Revised pgs to their Report entitled
Plant Unique Analysis for the Tourus
Support System.....to incorporate
changes required by our 9-14-76 ltr
.....(40 cys encl rec'd)

Re: Nine Mile Point Unit 1
Docket No. 50-220
DPR-63

In our October 1, 1976 letter we indicated that replacement pages to our Plant Unique Analysis for the Torus Support System would be provided to incorporate changes necessitated by your September 14, 1976 letter. Attached are revised Figures 14, 15 and Pages 59 and 73. Page 73 has been corrected to incorporate the proper references used in the Plant Unique Analysis.

Fig. 14 Anchor Bolt Displacement vs Time

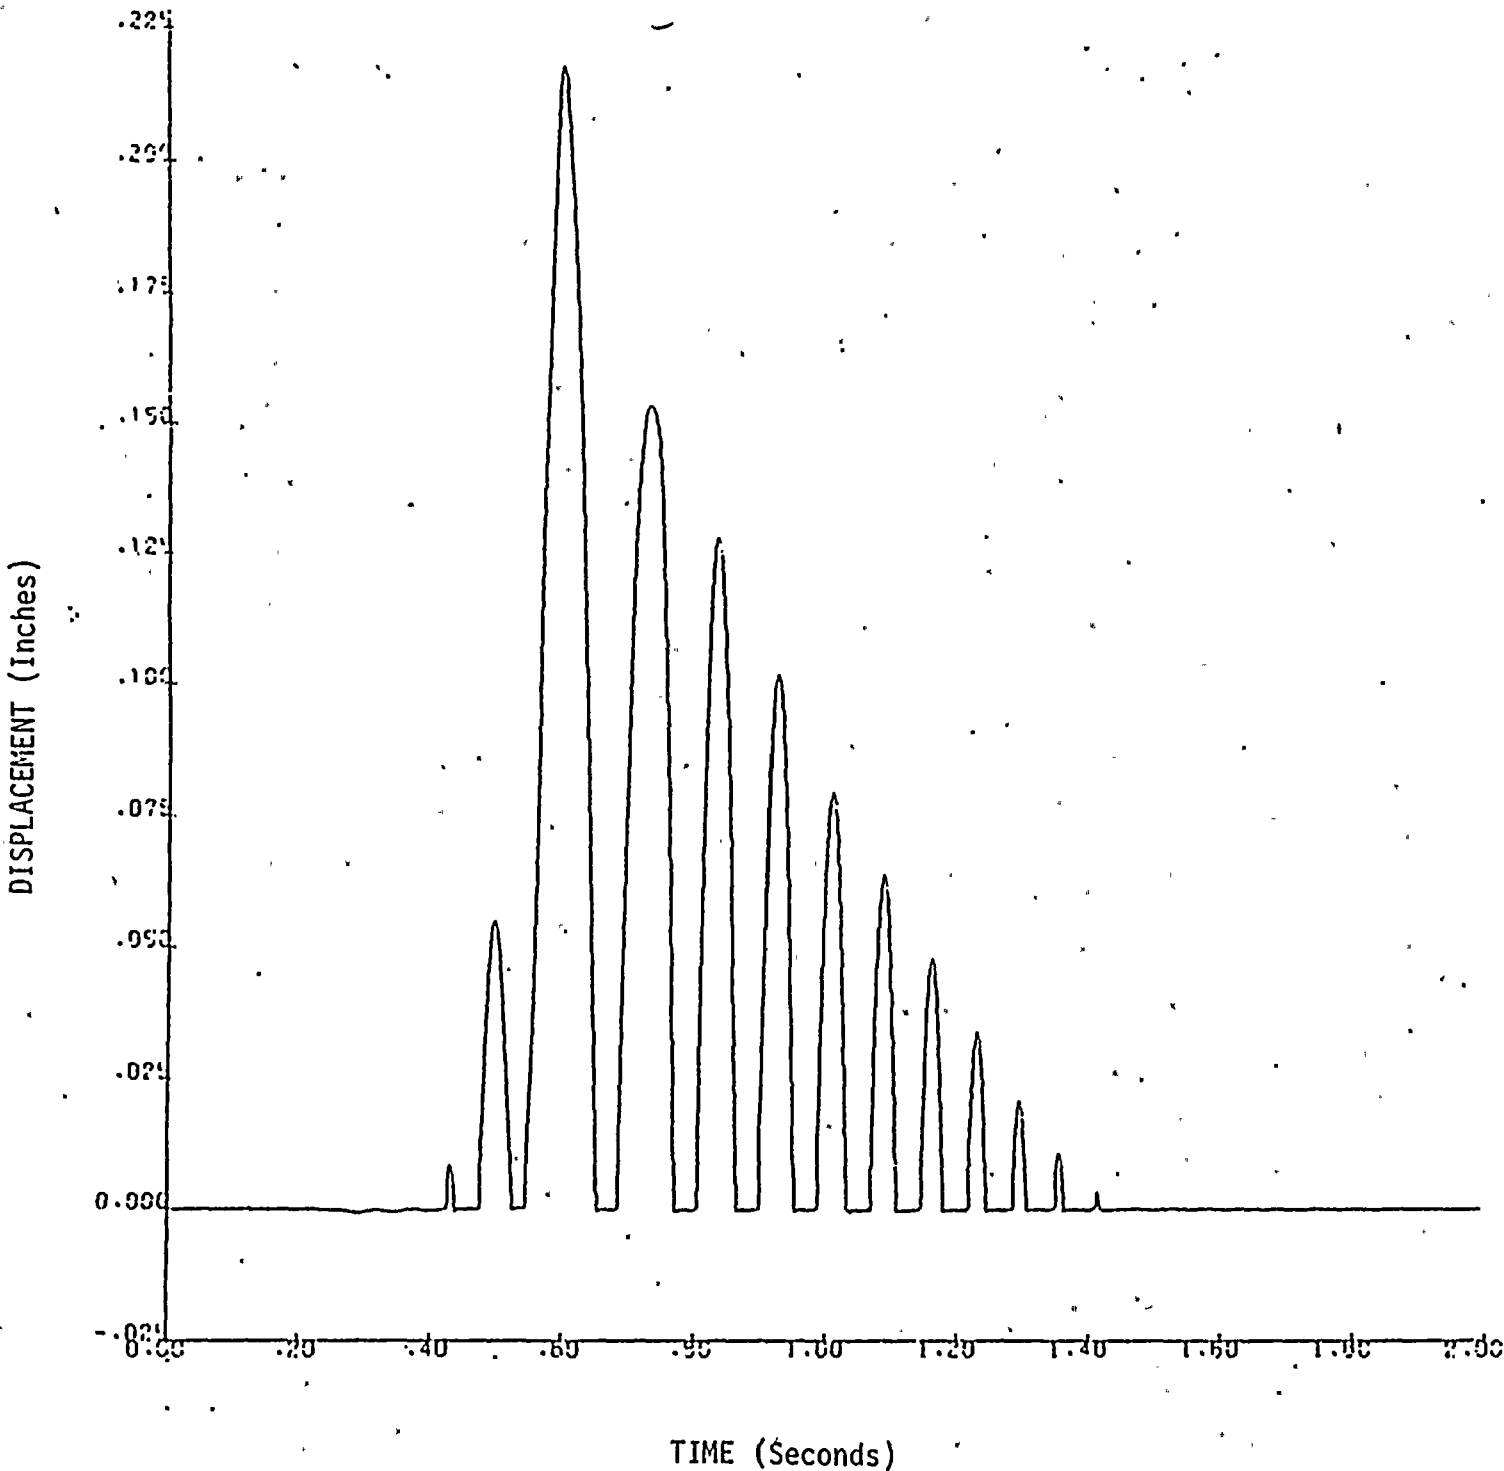
Verification of input parameters has been completed. The Design Basis Break Area was corrected to 5.446 square feet and the Vent Header outside diameter was corrected to 58.5 inches. These changes have a negligible effect on the results of the analysis.

Evaluation of the structural capacity of the anchor bolts to the STP criteria requires the use of the 1-D model results. Response plots of total anchor bolt deflection (including effects of concrete) and total column load (including deadweight) are presented in figures 14 and 15.
